**Re: GE-Pittsfield/Housatonic River Site  
Rest of River  
Comments on EPA's Model Validation Report**

**General Electric Company's Comments on the  
EPA Model Validation: Modeling Study of PCB  
Contamination in the Housatonic River**

**Quantitative Environmental Analysis, LLC  
Liverpool, NY**

**April 19, 2006**

**Figure 4-22b. Depth profiles of EPA high resolution cores collected during 1999.**

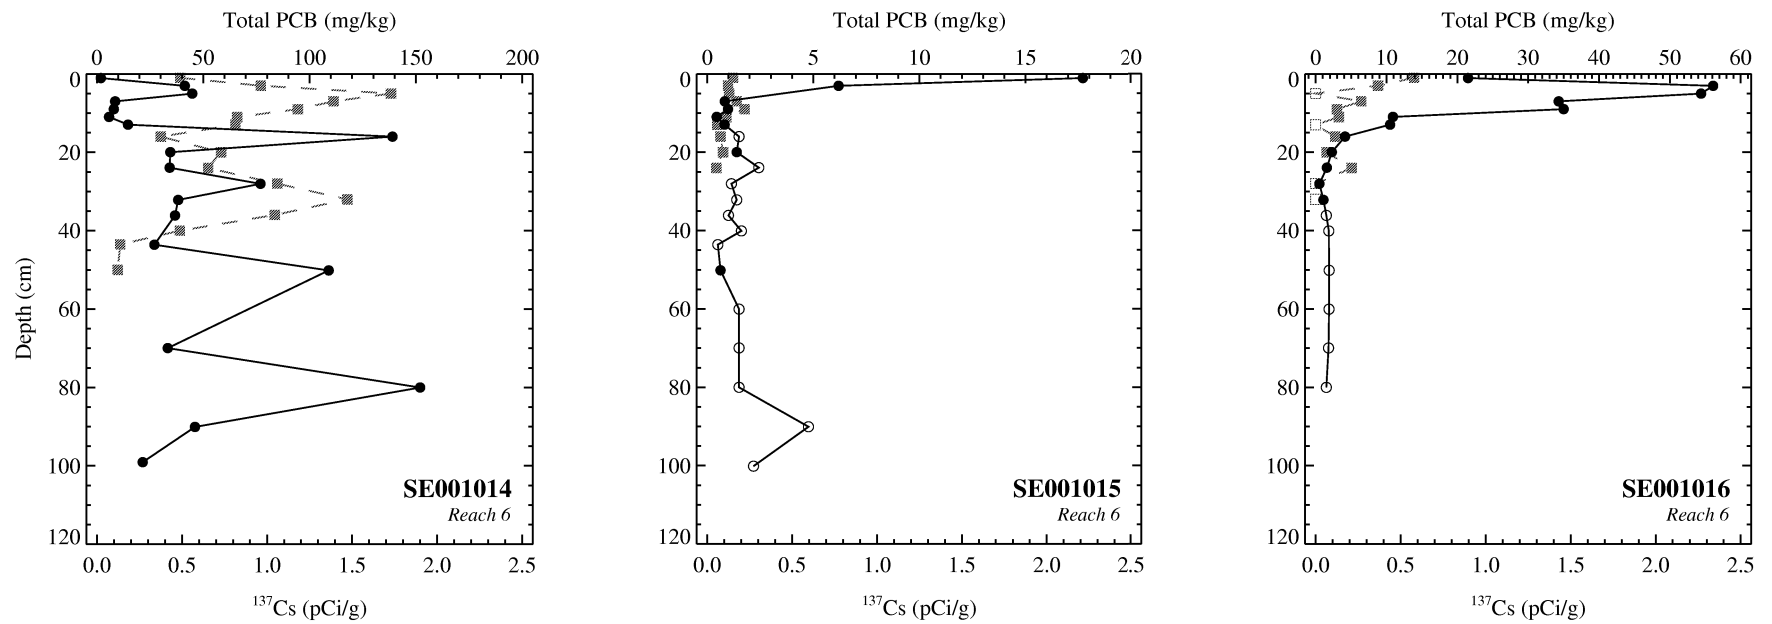
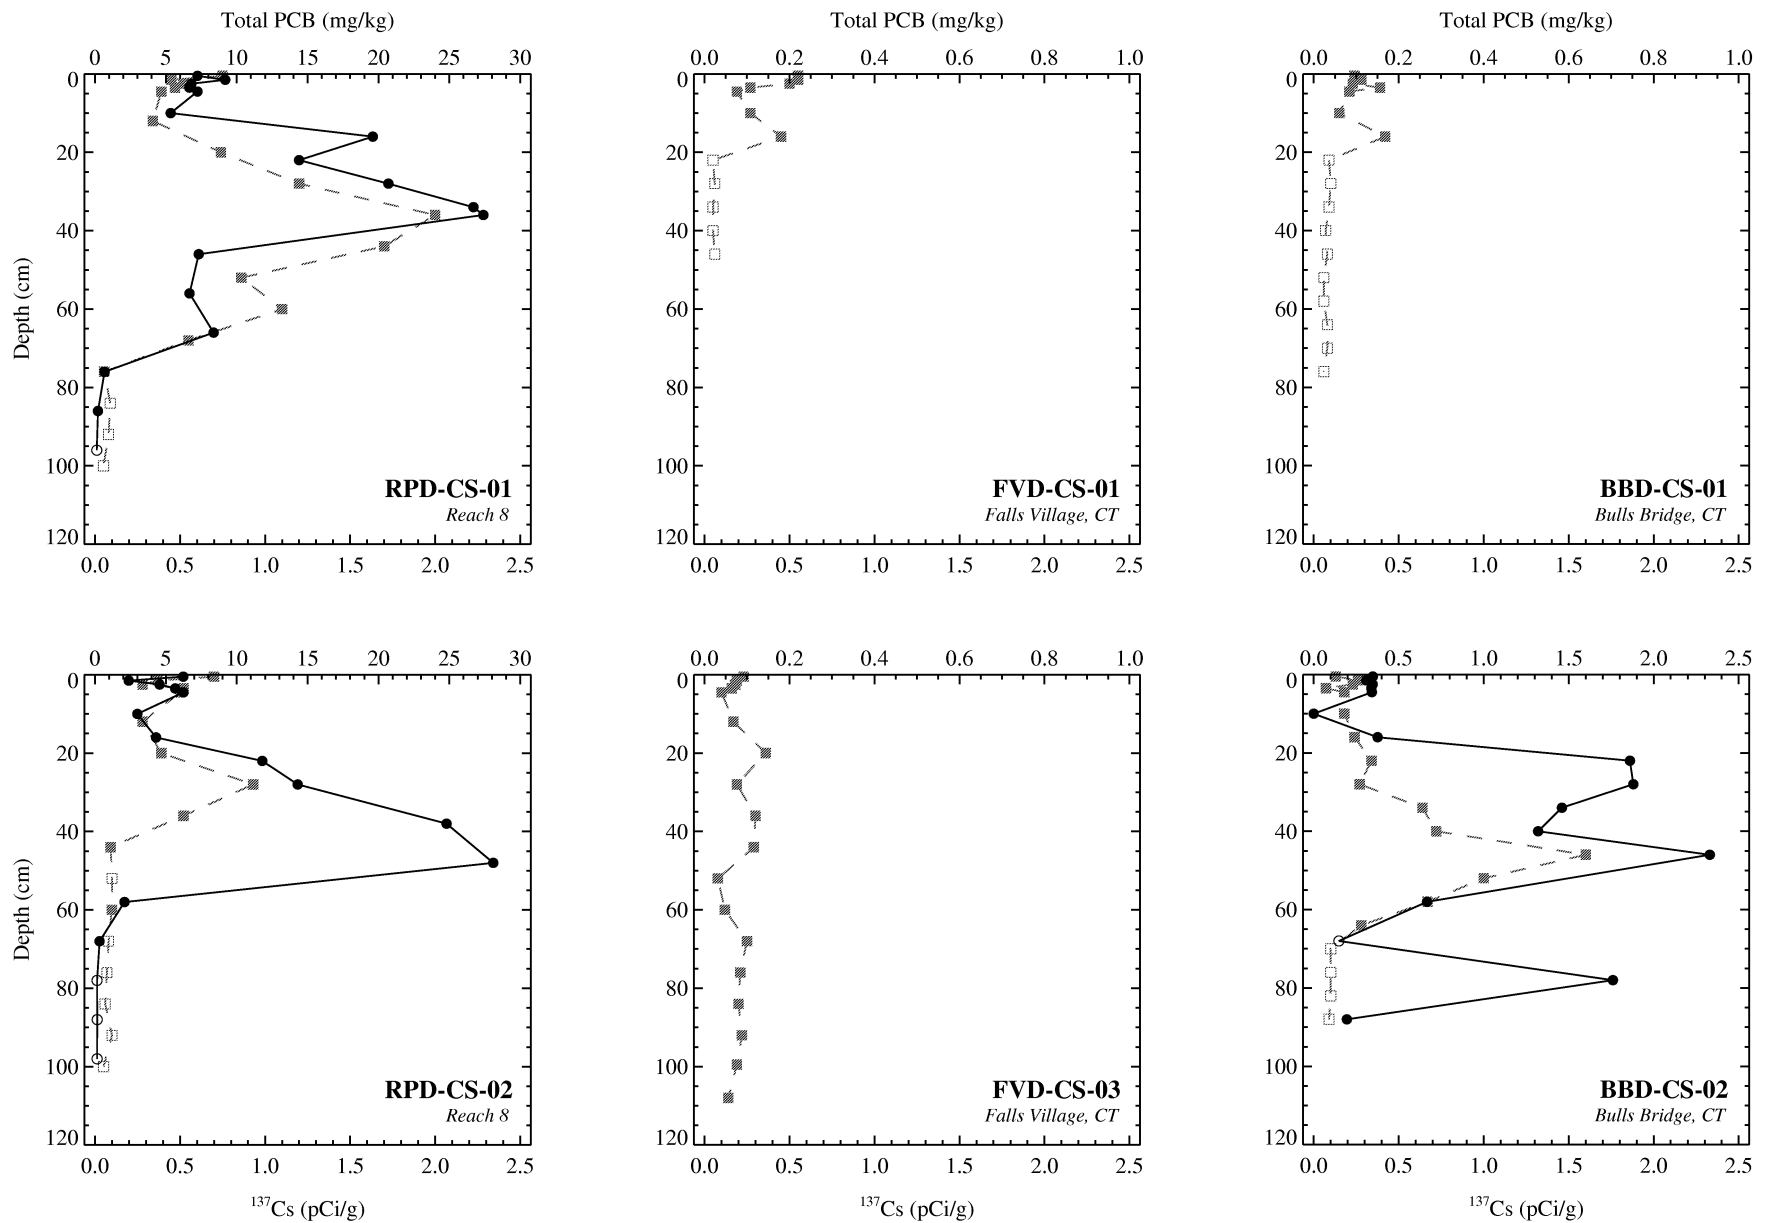
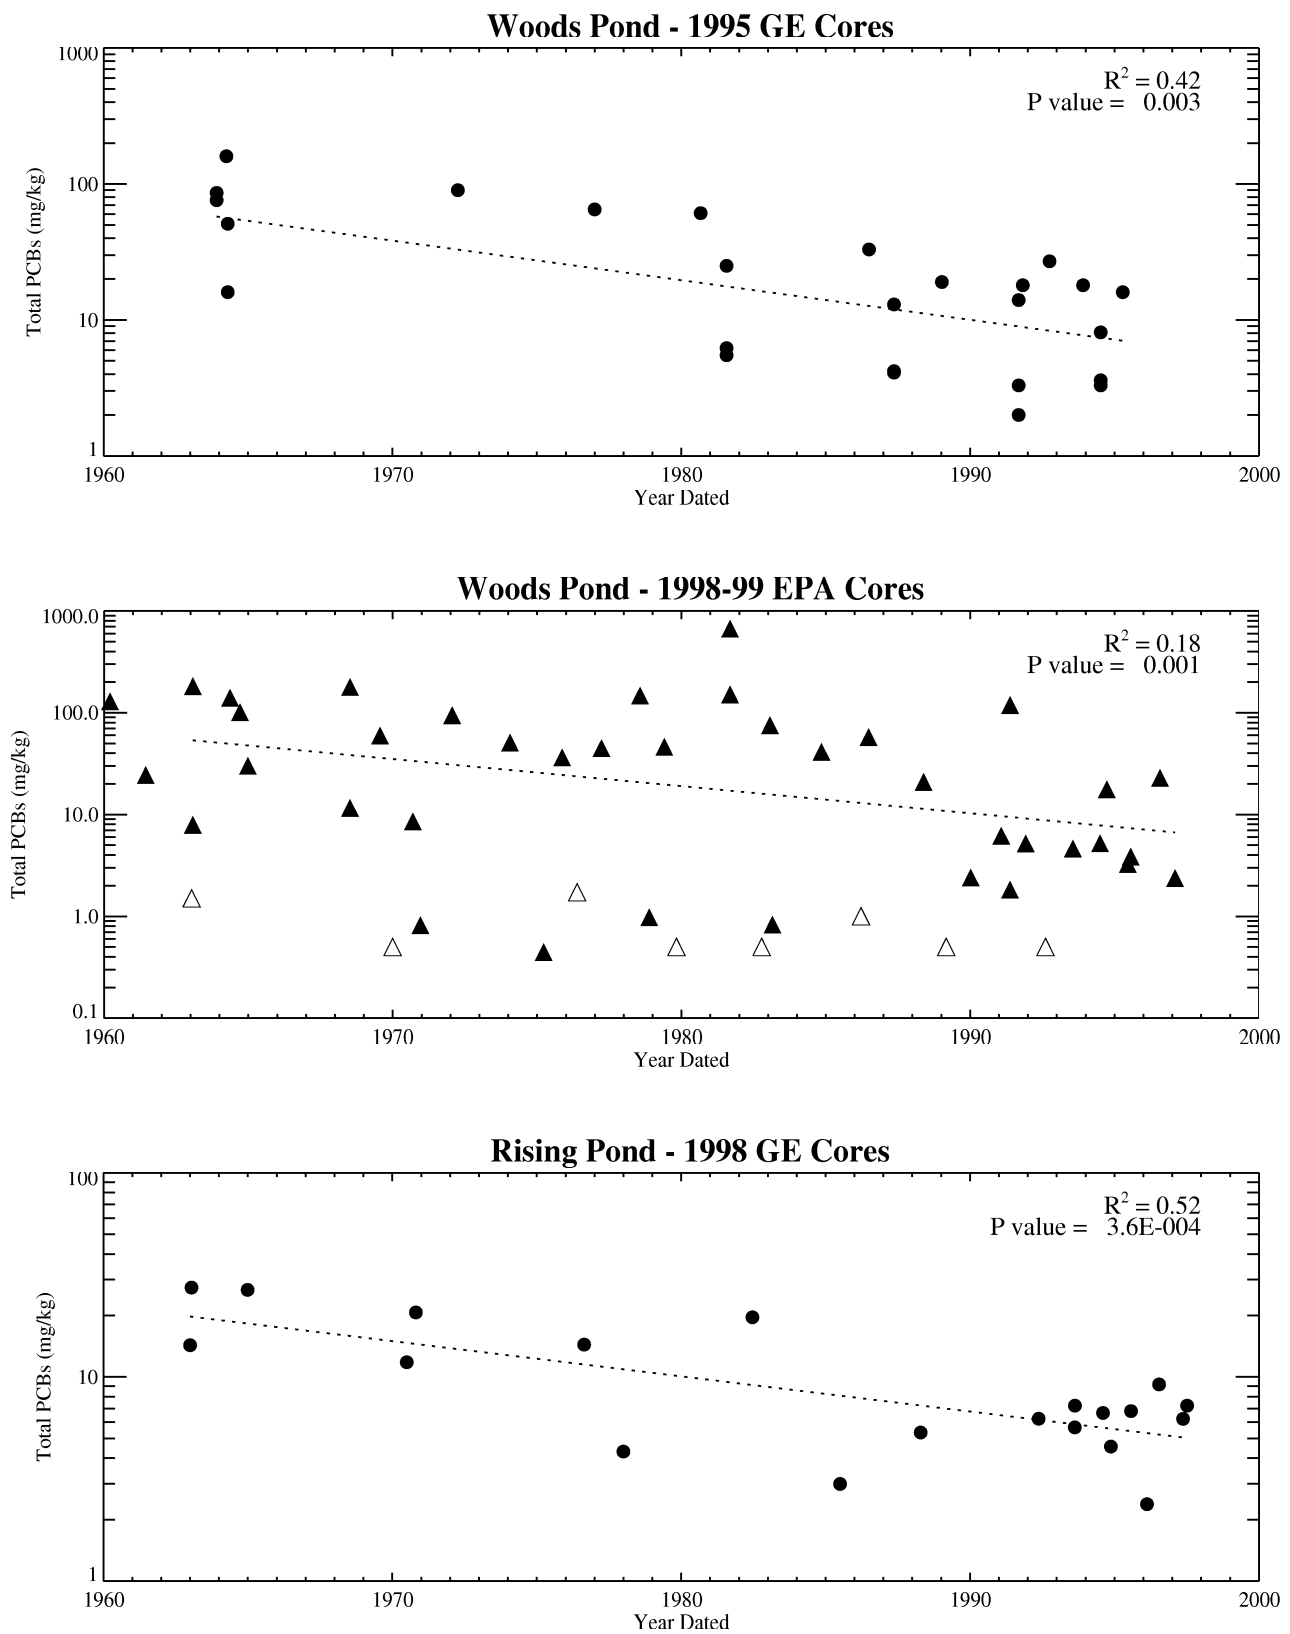
Finally, additional information on temporal trends in sediment PCBs is provided by the finely segmented cores that were collected by GE and EPA from various locations within the PSA (primarily Woods Pond) and dated using radioisotope techniques (see Section 4.5.4 of the RFI Report, excerpts of which are provided in Attachment 4). Model results for sediment PCBs (or PCB concentrations on depositing particles) should be compared to the estimated sediment PCB temporal trends from those cores (e.g., Figures 4-21, 4-22, and 4-26 in the RFI Report; see Attachment 4) as an additional test of the model's ability to reproduce the available information on temporal trends in the system.

- *Rising Pond High-Resolution Sediment Cores* – As described in the RFI Report, two finely segmented sediment cores were collected in 1998 from Rising Pond and analyzed for PCBs and the radioisotope Cesium-137 (BBL and QEA 2003, Section 4.5.4; see Attachment 4 to these comments). Although limited in number, these cores provide additional calibration data for the downstream model. First, the radioisotope data provide estimates of net sediment deposition rates that should be compared with results from the sediment transport model. Second, pairing of sediment radioisotope dating with vertical patterns in PCB concentrations from these cores provide a means of assessing the PCB fate model's ability to reasonably simulate temporal trends in the PCB concentration on depositing particles within Rising Pond.
